Subject: Siemens Westinghouse Power Corporation, "Missile Probability Analysis of BB81/281 13.9m²", TAC No. MB7964.

**RAI FOR
TOPICAL REPORT
"MISSILE PROBABILITY ANALYSIS OF BB81/281 13.9M²"
SIEMENS WESTINGHOUSE POWER CORPORATION
Response Submitted August 8, 2003**

CT-27332 Revision 2

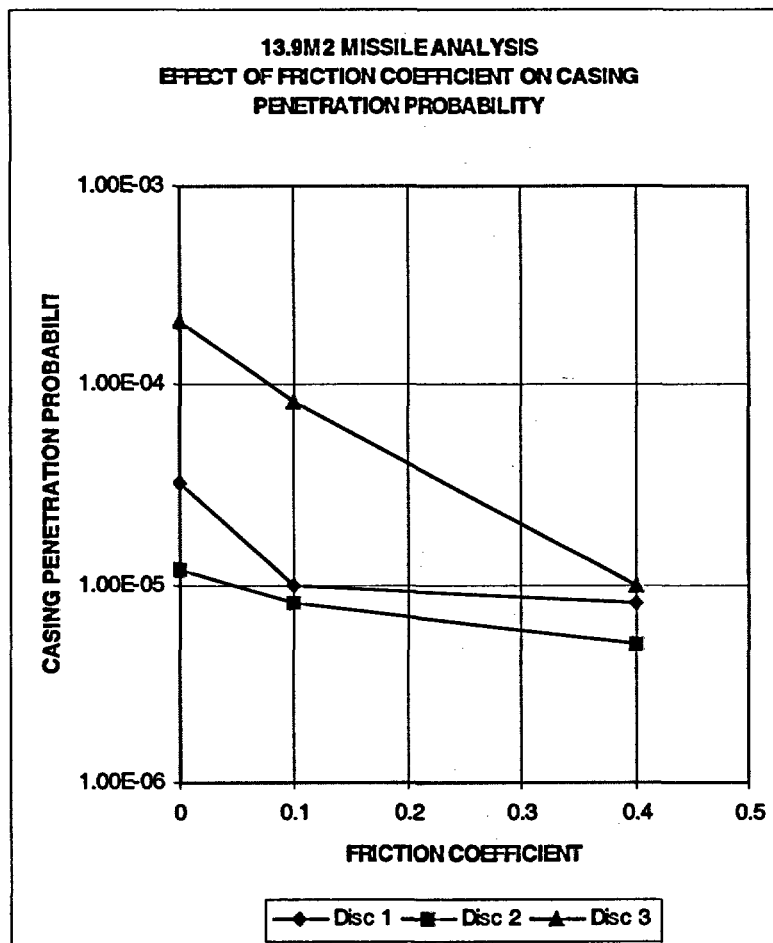
- (1) The staff's position regarding acceptable values for some key deterministic and probabilistic parameters used in a typical turbine missile analysis considering disk burst and casing penetration was stated in a safety evaluation (SE) of Siemens turbine missile methodology dated April 2, 2003. A list of these parameters is provided below:

Standard deviation for K_{Ic}
Initial crack depth
Maximum mean K_{Ic}
Maximum crack depth for considering crack branching
Mean value for the crack branching factor
Standard deviation for the crack branching factor
Bore stresses due to shrink fit with no record
Friction coefficient
Plant-specific parameters

Please identify the parameters in your current analysis that assumed different values or probabilistic distributions than their corresponding ones accepted by the staff in the April 2, 2003 SE and assess the impact of the differences on your results and conclusion.

Unfortunately, the 13.9m² missile analysis documented in CT-27332 Revision 0 was performed in the Fall of 2002, the original Missile Report issued in February 2003 and the NRC Safety Evaluation (SE) in April 2003. Because of these time differences, there are differences in the input parameters used and those recommended by the NRC staff in the SE. As summarized in the attached tabulation, the two input parameters that were not consistent with the NRC staff recommendations are maximum crack depth for considering crack branching and friction coefficient in the casing penetration calculations.

With regard to maximum crack depth for considering crack branching, the missile analysis has been revised to use the 3-inch criterion. Reference Revision 2 of CT-27332 as attached in a separate document. This revised report complies with all of the NRC recommendations for input parameters.

The casing penetration analysis used in CT-27332 Revision 0 is the same existing analysis used for the Limerick design, which applies and is discussed in ER9605 (one of the submittals to the NRC). This analysis used a friction coefficient of 0.40. Use of a 0.25 friction factor per latest NRC recommendation results in increased casing penetration probabilities for each disc. Revision 2 of CT-27332 includes the effect of the 0.25 friction coefficient in the missile energy calculations.

A sensitivity study was performed for the purpose of evaluating the effect of friction coefficient on casing penetration probability. Results are summarized on the following figure. Calculations were made for each of the three discs at friction coefficients of 0.40 (same as Limerick), 0.10 and zero. The zero case was made assuming no friction between disc fragments, blades and casings during energy dissipation within the LP turbine after burst.

Fig. 14: Tangential Stress Distribution at Rated Speed (N/mm^2)

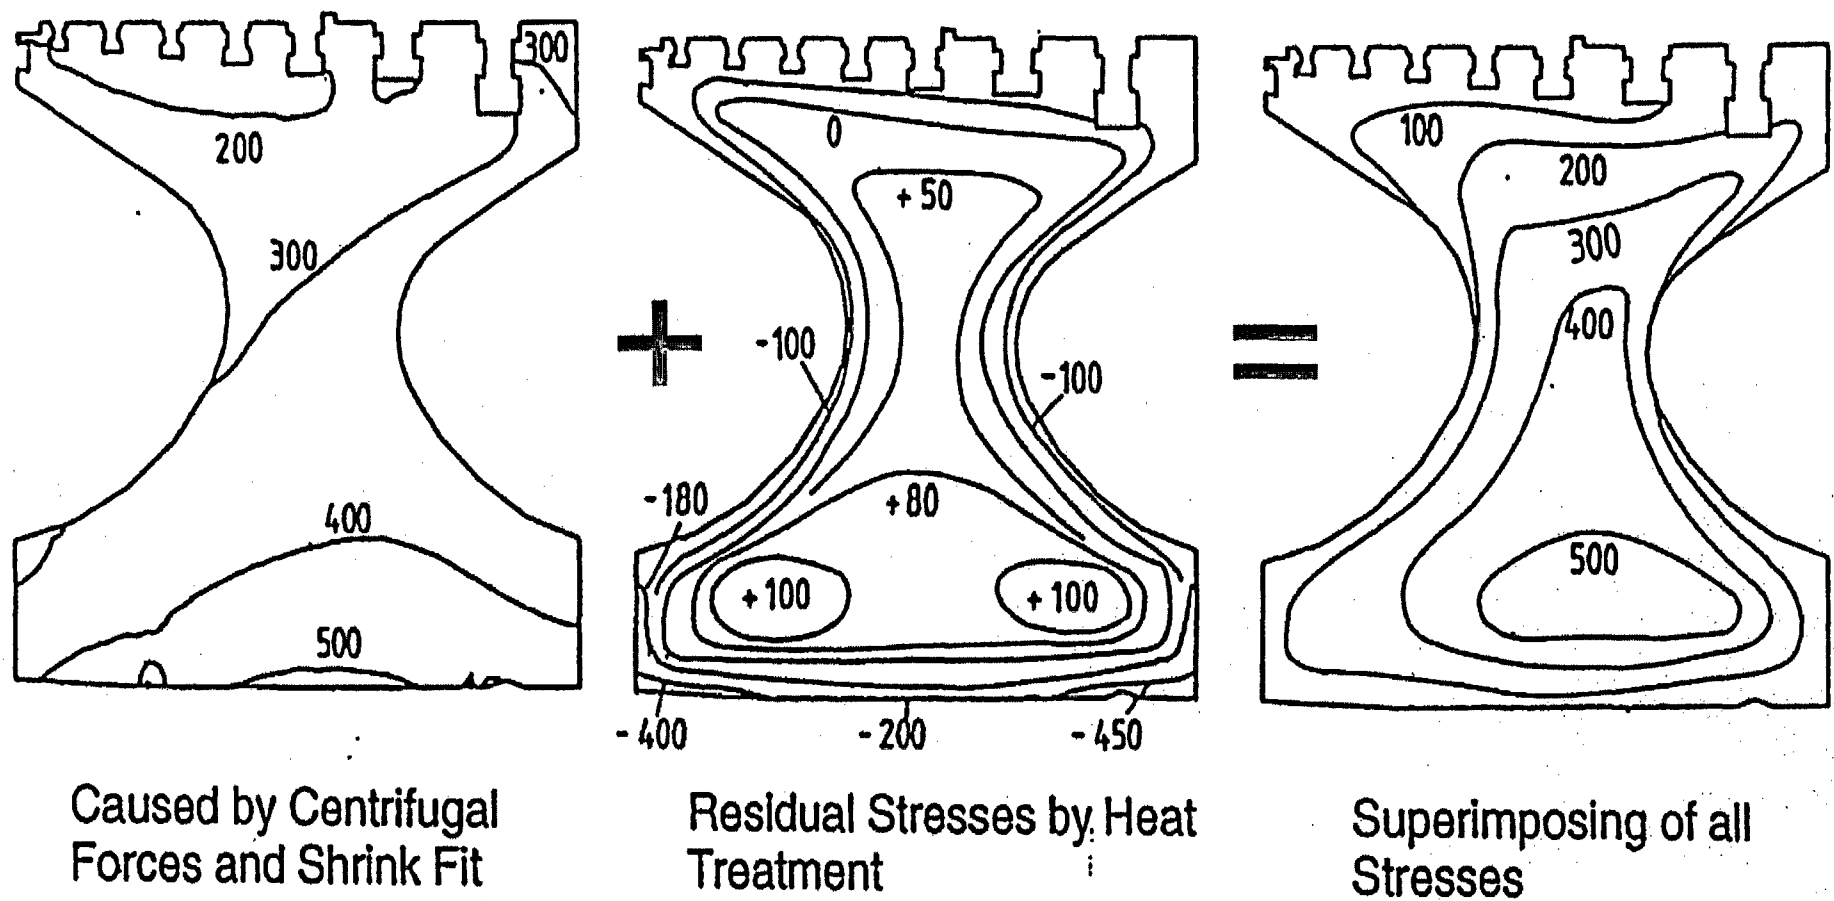
- (2) Section 3.3 and Figure 8 present the residual stress distribution due to manufacturing without adequate explanation. Please provide basis for this residual stress distribution, e.g., analytical (FEM) results with experimental verification. Also, the effective stresses should include tensile stresses due to shrink-fit. Update Figure 8 to reflect this modification, and assess its impact on your results and conclusion.

This paper provides the most current basis for residual stress distribution along with analytical results and experimental verification. Figure 14 in the technical paper superimposes the centrifugal forces, tensile stresses due to shrink fit and residual stresses, as requested. The result is essentially the same conclusion as presented in Figure 8 of CT-27332 for BB81/281 13.9m² LP turbines. The only difference is that Figure 8 is based on results at 120% of rated speed, whereas Figure 14 in the technical paper is based on results at rated speed. Therefore, we believe that Figure 8 applies and does not need to be updated.

Fig. 9 Results of the investigation on crack initiation

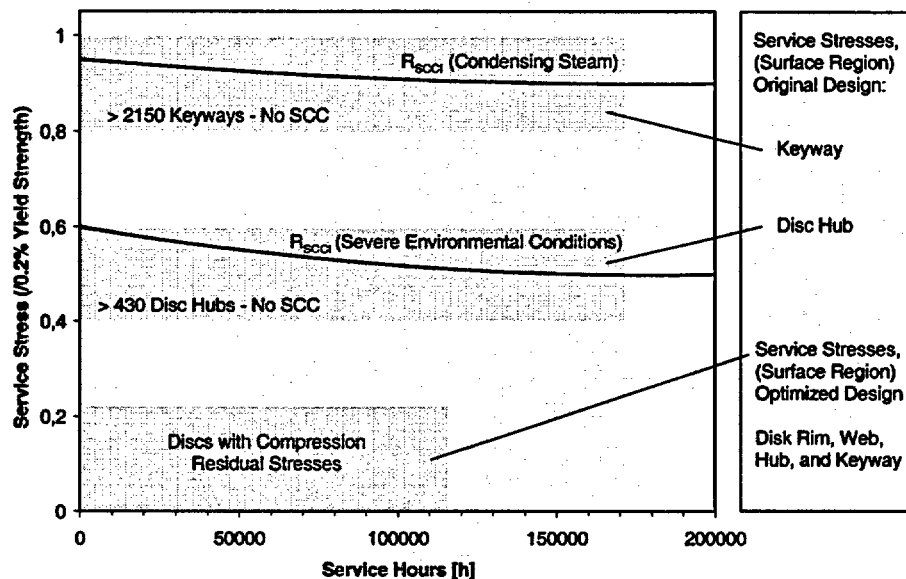
- (3) Section 3.4.7.1 mentions that "...using standard statistical evaluation procedures, the crack initiation probabilities at 90% confidence level for the #1 disks are as shown in Table 2." Provide information regarding this standard statistical evaluation procedure. The information should include the number of indications, the number of reactor years or the number of disks, and the assumed probability distribution (e.g., log-normal or binomial).

For large values of N (disk number) or small values of n (disks with flaws), the estimated probability of crack initiation "p" is small ($p < 0.1$), and the binomial distribution can be approximated by a Poisson distribution.

The bounds for the Poisson parameter λ at a confidence level of 90% are [0.1; 3.89] for 1 indication (among 82 #1 disks) and [0.53; 5.3] for 2 indications (among 324 back end disks), independent on the sample size N.

The upper value of the Poisson parameter at 90% Confidence Level for $n = 1$, $\lambda = 3.89$ and with $N = 82$:

$$p = (\lambda / N) = (3.89 / 82) = 0.047$$

The upper value of the Poisson parameter at 90% Confidence Level for $n = 2$, $\lambda = 5.3$ and with $N = 324$:

$$p = (\lambda / N) = (5.3 / 324) = 0.0164$$
